# Access Compliance Report

## Public Rights-of-Way

Intersection ID: 4095	Main Street: MALLARD_COVE_CT	Cross Street: MALLARD_RIDGE_DR	Location: SE
ADA ID: DC0B641CA101	Ramp Type: Perp	Initial Pass/Fail: Fail	Overall Compliance: No
Severity Score: 8.75			
Codes/Mitigation Info/Possible Solution		Field Measurements/Component Compliance

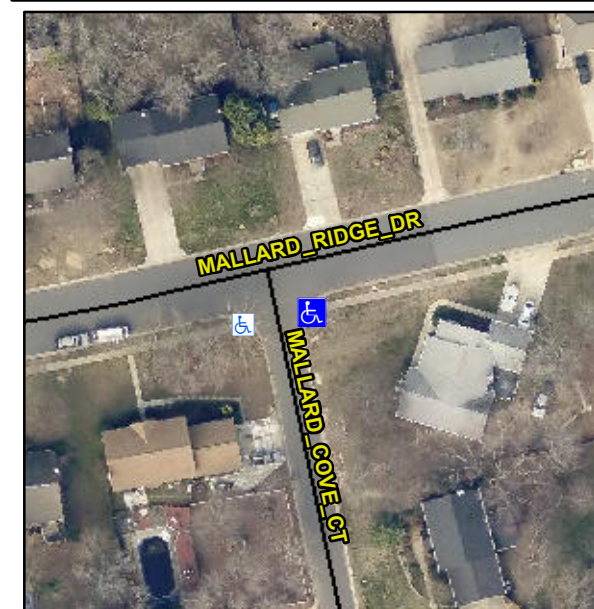
**Not Found, R304.5.1**

Compliance	Description	Data	Compliance	Description	Data
N/A	Ramp Length (in)	60.0	Yes	Ramp Slope (%)	7.7
No	Ramp Width (in)	47.5	Yes	Ramp XSlope (%)	0.3
N/A	Flare Type LT	N/A	N/A	Flare Type RT	N/A
N/A	Flare Slope LT (%)	N/A	N/A	Flare Slope RT (%)	N/A
N/A	Flare Traversable LT?	N/A	N/A	Flare Traversable RT?	N/A
N/A	Landing Length (in)	N/A	N/A	DWS Provided?	N/A
N/A	Landing Width (in)	N/A	N/A	DWS Contrast?	N/A
N/A	Landing Slope (%)	N/A	N/A	DWS Length (in)	N/A
N/A	Landing X Slope (%)	N/A	N/A	DWS Full Width?	N/A
N/A	Landing Curb? (Y/N)	N/A	N/A	DWS Offset (in)	N/A
N/A	Shared Landing?	N/A			
N/A	Gutter Ponding?	N/A	N/A	Gutter Slope (%)	N/A
N/A	Gutter Lip Ht (in)	N/A	N/A	Gutter X Slope (%)	N/A
N/A	Painted X Walk1?	No	N/A	Painted X Walk2?	N/A
	X Walk 1 Direction	To W		X Walk 2 Direction	N/A
N/A	X Walk 1 Width (in)	N/A	N/A	X Walk 2 Width (in)	N/A
	X Walk 1 Slope (%)	4.7		X Walk 2 Slope (%)	N/A
	X Walk 1 X Slope (%)	3.8		X Walk 2 X Slope (%)	N/A

**Remove & Replace Entire Ramp.**
